# SAN FRANCISCO PLANNING DEPARTMENT

## Certificate of Appropriateness Case Report

*Filing Date:* June 3, 2013  
*Case No.:* **2013.0693A**  
*Project Address:* **940 Grove Street**  
*Landmark District:* Alamo Square  
*Zoning:* RH-3 (Residential, House, Three-Family)  
40-X Height and Bulk District  
*Block/Lot:* 0798 / 010  
*Applicant:* Lucian Blazej  
50 Laidley Street  
San Francisco, CA 94131  
*Staff Contact* Shelley Caltagirone - (415) 558-6625  
shelley.caltagirone@sfgov.org  
*Reviewed By* Tim Frye – (415) 575-6822  
tim.frye@sfgov.org

NORTH ELEVATION PROPOSED  
 SHOWING ADJACENT BUILDING

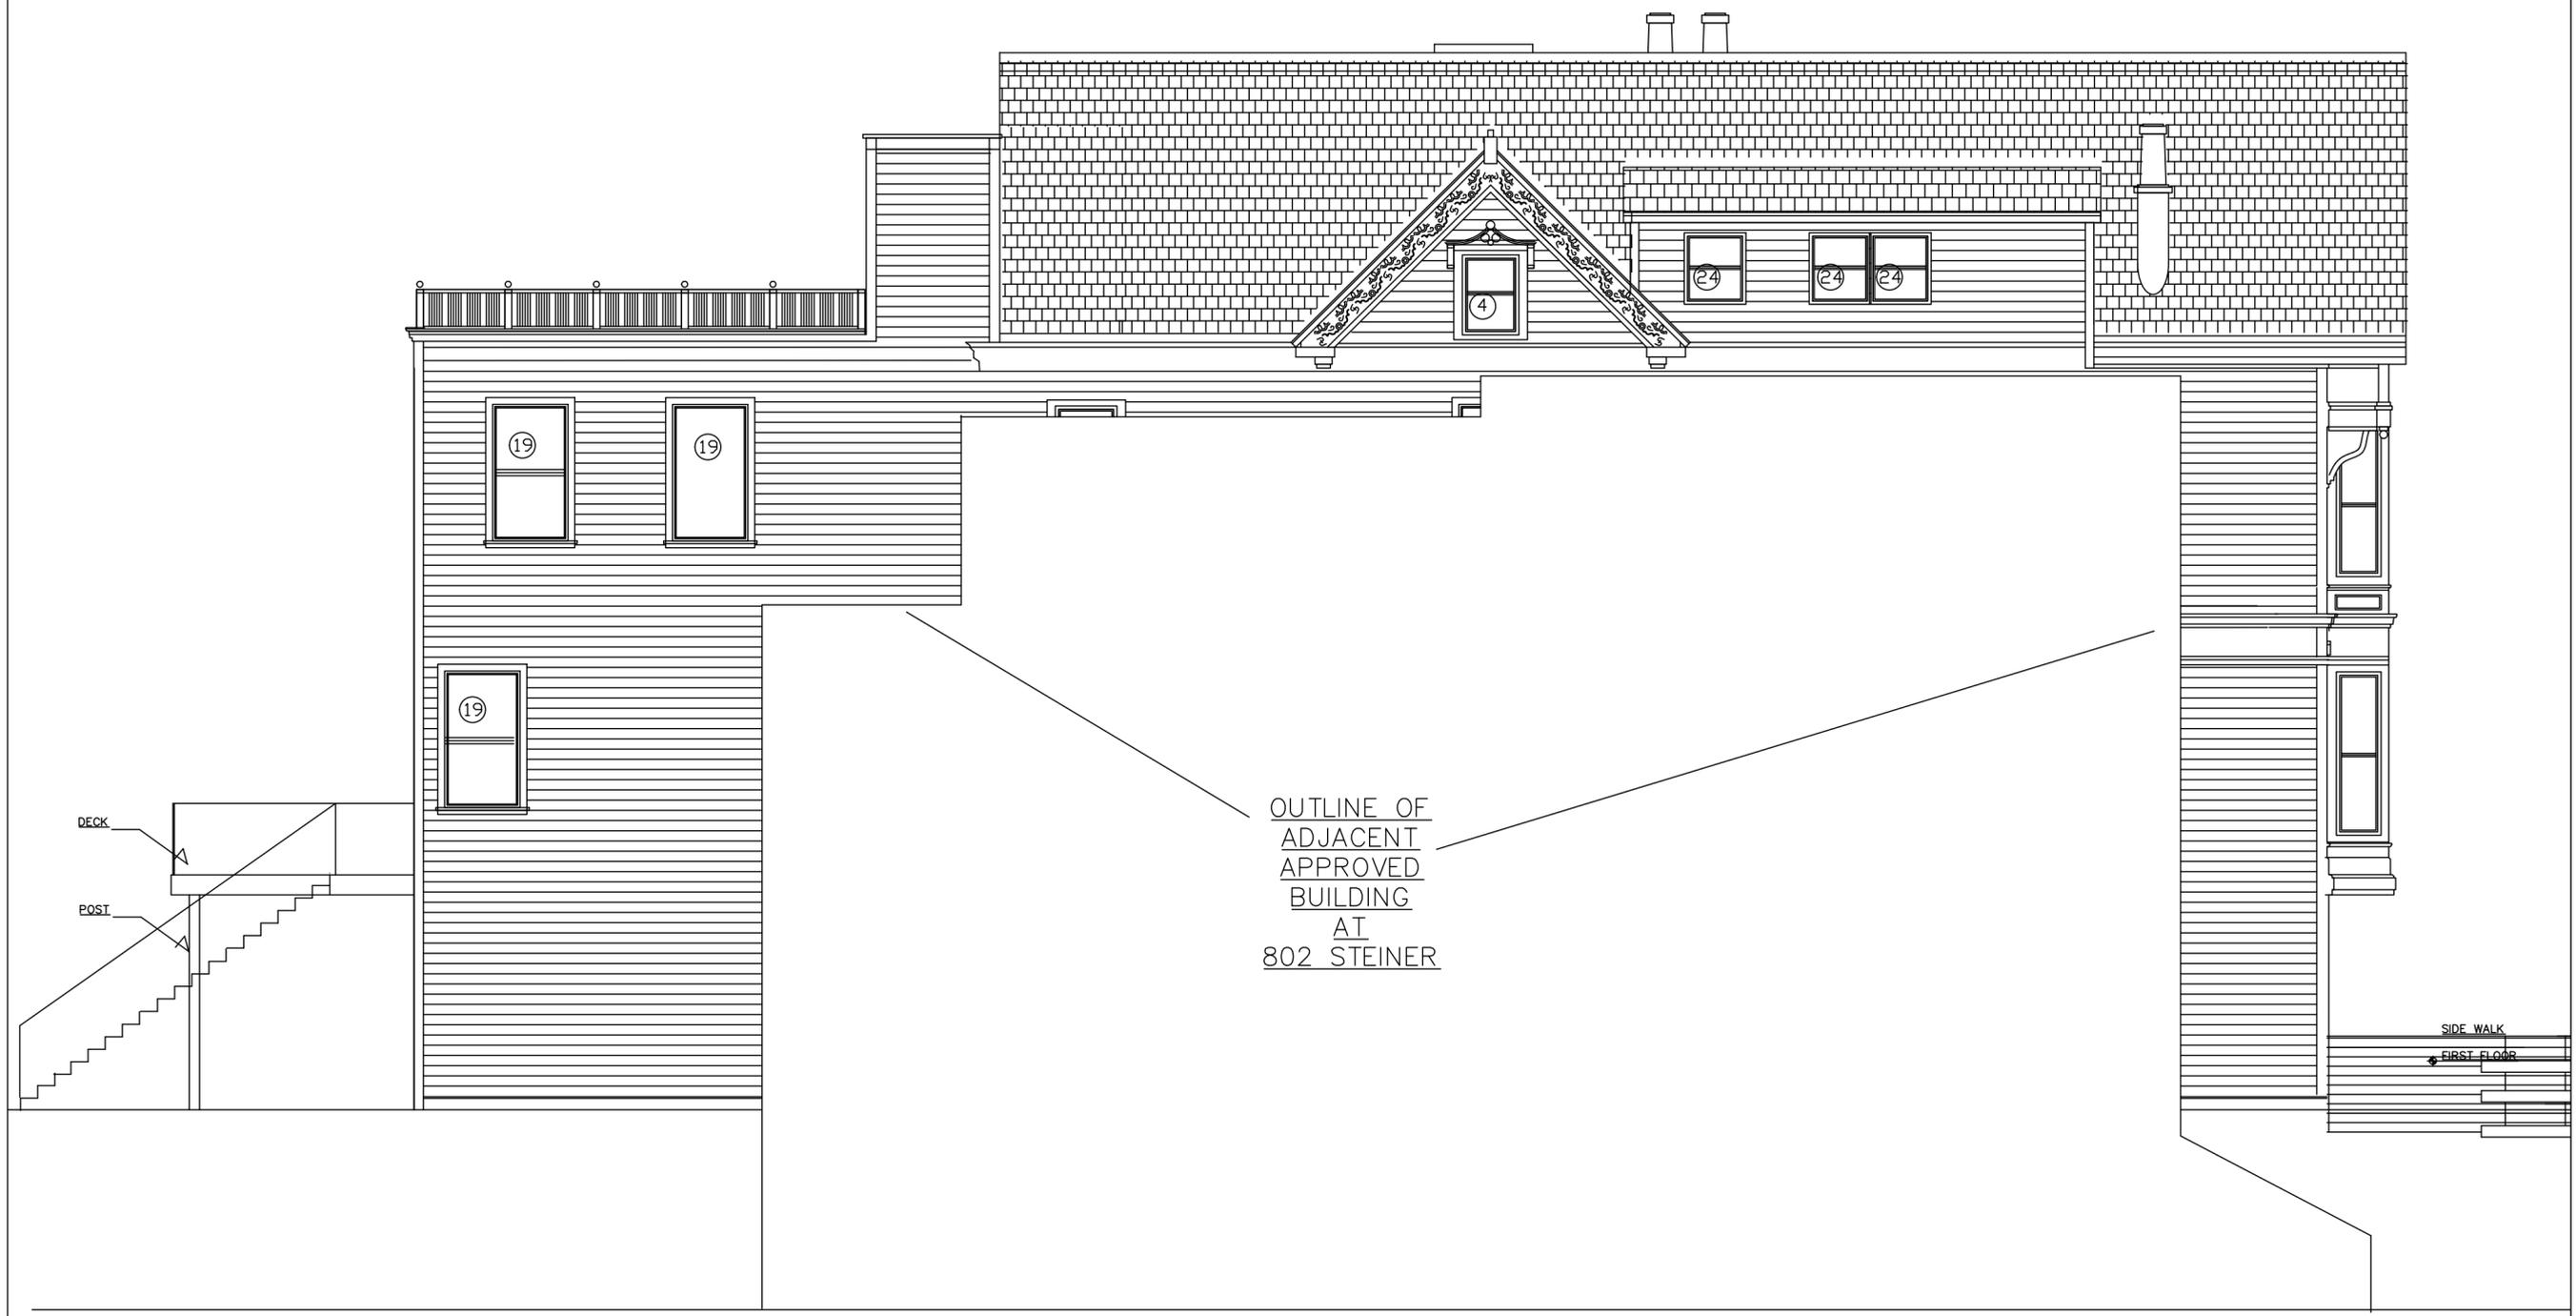
- (4) Replace the historic wood siding at the north and east façades with a simplified board and trim pattern and remove the original stringcourse and cornice details. Photographs and the written description from the 2009 Historic Resource Evaluation Report (attached) indicate that the original portions of these façades maintained the same pattern of wood siding as the south and west façades with tongue-and-groove siding at the second story, channel drop siding at the first story, and beaded siding over a faux-coursed concrete foundation. They also featured the same stringcourses and cornice details. Portions of the original siding at both the north and east facades were removed or damaged by the school additions in the latter half of the century. The previous approval allowed for the in-kind replacement of the historic siding and matching infill in the areas of loss where the school additions were removed at the north façade. Instead, the cladding has been replaced with uniform 7½"-wide wood channel drop siding with no historic stringcourse or cornice detailing. The completed work is shown in the attached photographs.

- The project sponsor shall replace the siding at the north and east elevations with new siding, stringcourses, and cornice details that match the original detailing as shown in the historic and pre-project photographs.

COMPARATIVE GARAGE ENTRY SECTIONS

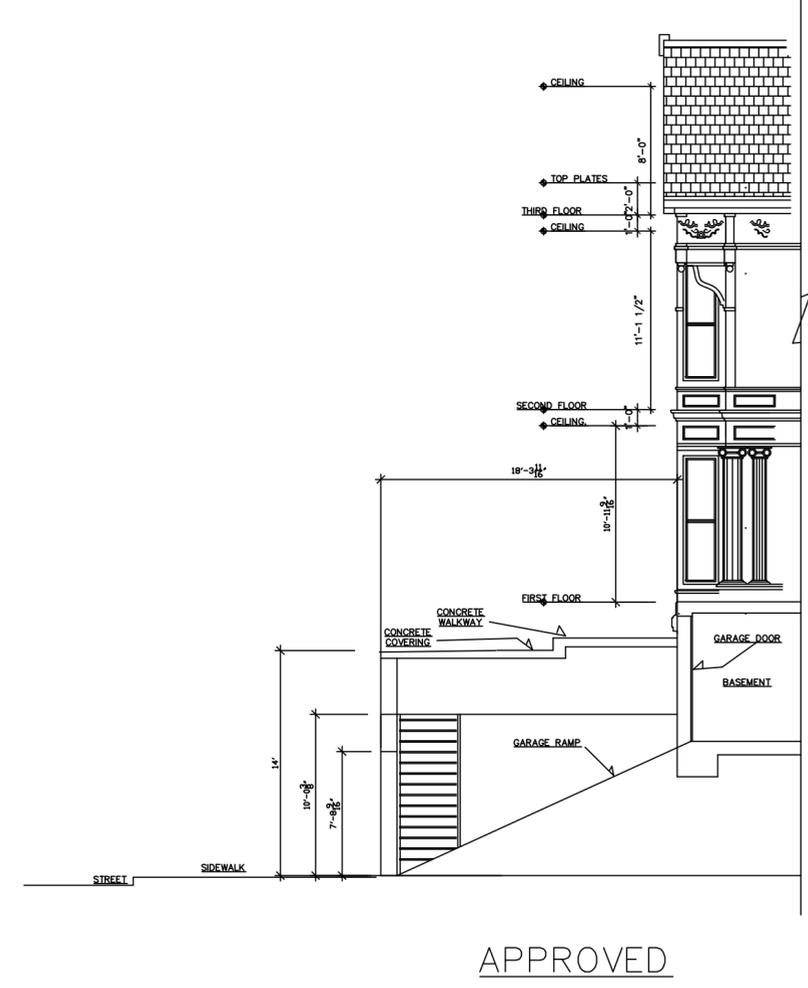
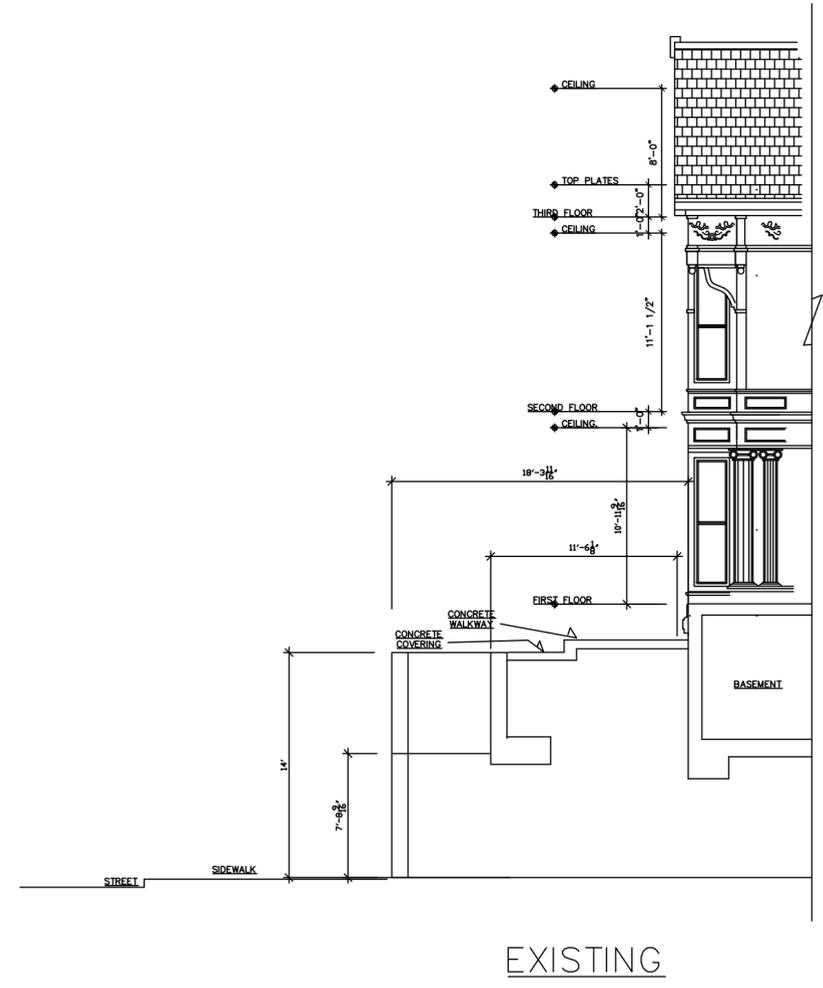
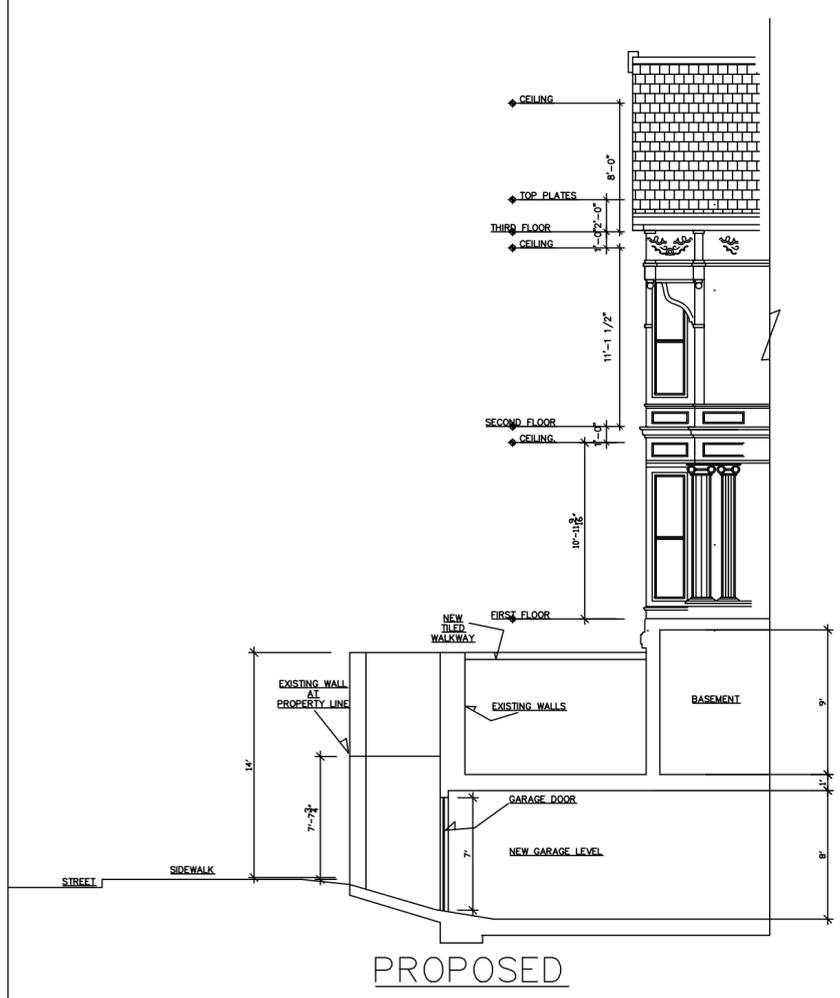
- (1) Modify the configuration and location of the previously approved garage. Previously, the HPC approved plans for a 16'-wide garage door entering at the basement level of the front facade. The new proposal would lower the garage to a sub-basement level and move the entry towards the property line. The door width would be narrowed to an 11'. Relocation of the garage would allow for retention of the terraced landscaping in the front yard. The secondary retaining wall would be extended 20" in height and a 22.5" railing would be installed on top to create a safety barrier above the driveway. The front yard would be partially paved.

*The proposed garage will require removal of a portion of the historic retaining wall at the south property line; however, the majority of the wall will remain and the overall design of the terraced landscape will be legible. Currently the proposal includes raising the height of the secondary retaining wall, which would change the character of the historic wall and the building's setting. Staff recommends that the existing wall height be maintained in order to comply with this Standard.*

- The project sponsor shall maintain the heights of the historic retaining walls.
- The project sponsor shall revise the railing design above the garage so that it is lighter in appearance.

- The project sponsor shall install a solid wood garage door with a painted finish similar in tone to the surrounding wall finishes.
- The project sponsor shall include all railing, door, and landscaping details in the building permit plans to be reviewed and approved by Department preservation staff.
